DOCUMENT CHANGE NOTICE (DCN)

DOCUMENT No. (DOC-REV-GP. ID)	TITLE	NEW REV.
D960136-B-D	LOS Bracket, Sensor/Actuator, Bottom	C
D960137-B-D	LOS Bracket, Sensor/Actuator, Top	C

DCN E980832

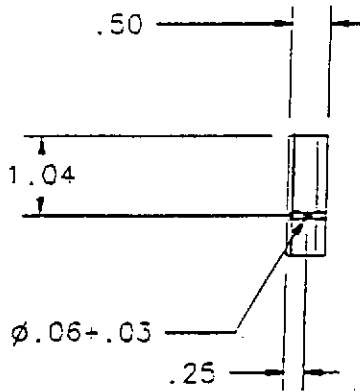
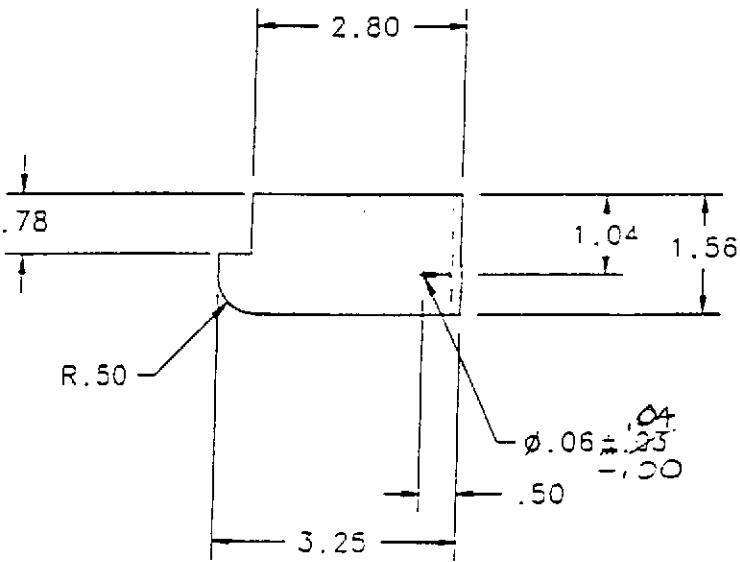
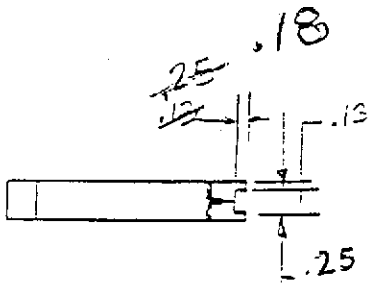
CHANGE DESCRIPTION (FROM/TO): Due to the angled fly cut defined at the next assembly, the welding stub(defined on Rev. B) is insufficiently thick at the inside corner. The depth of the cleaning slot behind the brackets needs to be reduced from 0.25" to 0.18".
